Access Compliance Report

Public Rights-of-Way

(Curb Ramps)

Intersection ID: 10041631	Main Street: WHITEHALL_PARK_DR	Cross Street: N/A	Location: NE
ADA ID: 24F35CD692D9	Ramp Type: PerpDiag	Initial Pass/Fail: Fail	Overall Compliance: No
Severity Score: 33.75			
Codes/Mitigation Info/Possible Solution		Field Measurements/Component Compliance

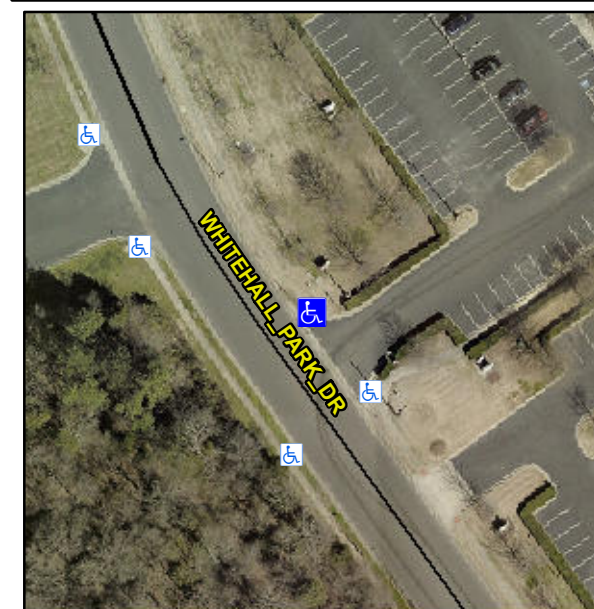
Not Found, R304.5.1, R304.2.2, R304.5.3

Compliance	Description	Data	Compliance	Description	Data
N/A	Ramp Length (in)	48.0	No	Ramp Slope (%)	9.5
No	Ramp Width (in)	42.0	No	Ramp XSlope (%)	5.7
N/A	Flare Type LT	N/A	N/A	Flare Type RT	N/A
N/A	Flare Slope LT (%)	N/A	N/A	Flare Slope RT (%)	N/A
N/A	Flare Traversable LT?	N/A	N/A	Flare Traversable RT?	N/A
N/A	Landing Length (in)	N/A	N/A	DWS Provided?	N/A
N/A	Landing Width (in)	N/A	N/A	DWS Contrast?	N/A
N/A	Landing Slope (%)	N/A	N/A	DWS Length (in)	N/A
N/A	Landing X Slope (%)	N/A	N/A	DWS Full Width?	N/A
N/A	Landing Curb? (Y/N)	N/A	N/A	DWS Offset (in)	N/A
N/A	Shared Landing?	N/A			
N/A	Gutter Ponding?	N/A	N/A	Gutter Slope (%)	N/A
N/A	Gutter Lip Ht (in)	N/A	N/A	Gutter X Slope (%)	N/A
N/A	Painted X Walk1?	No	N/A	Painted X Walk2?	No
	X Walk 1 Direction	To SW		X Walk 2 Direction	To SE
N/A	X Walk 1 Width (in)	N/A	N/A	X Walk 2 Width (in)	N/A
	X Walk 1 Slope (%)	8.3		X Walk 2 Slope (%)	0.7
	X Walk 1 X Slope (%)	1.0		X Walk 2 X Slope (%)	9.0

Remove & Replace Curb Ramp With Two New Directional Ramps or Equivalent.
